Presentation to the ACRS Subcommittees on Thermal-Hydraulic Phenomena

June 26, 2002

Rod Bundle Heat Transfer (RBHT) Project

FUEL ENTHALPY DURING A RAPID BORON DILUTION EVENT IN A PWR

POWER AND PEAK FUEL PELLET ENTHALPY

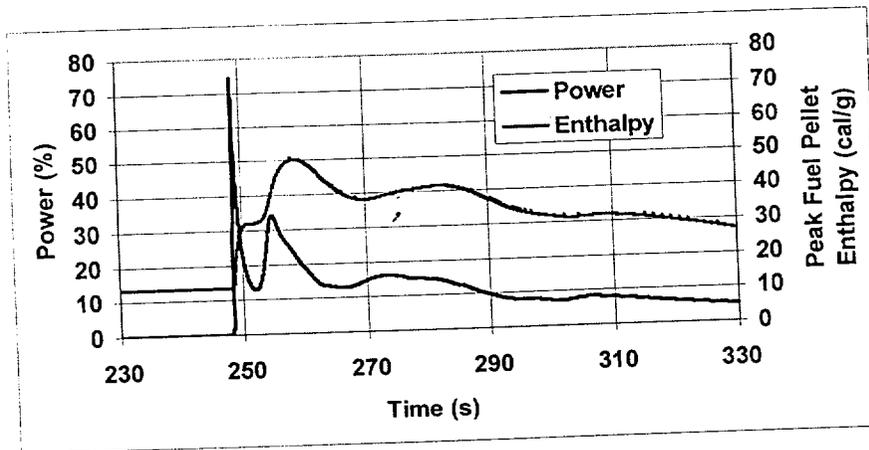
1 If you look at the peak change in fuel
2 enthalpy, you see that it goes up maybe a total of 37
3 calories per gram from here to here. (Indicating.)
4 But if there was going to be any fuel failure, it
5 would probably be the result of this initial increase
6 in enthalpy. So that's fairly low.

MAXIMUM LOCAL VOID FRACTION (DIMARZO CURVE)

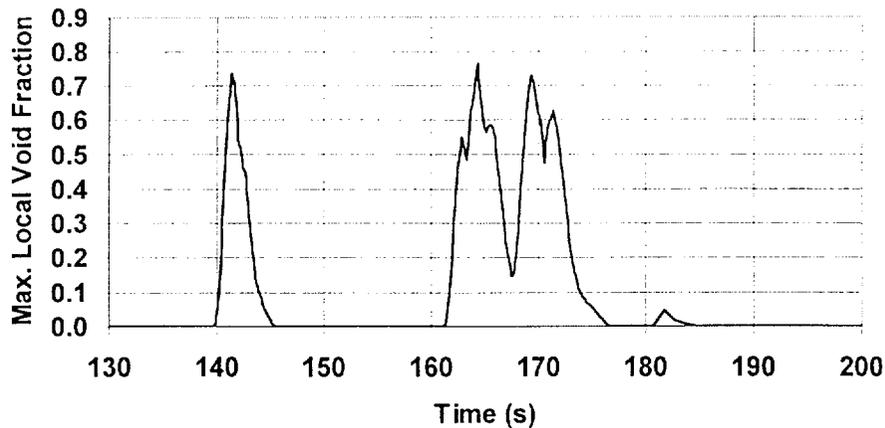
17 DR. DIAMOND: There is a little bit. I'll
18 show that momentarily. There is some boiling.
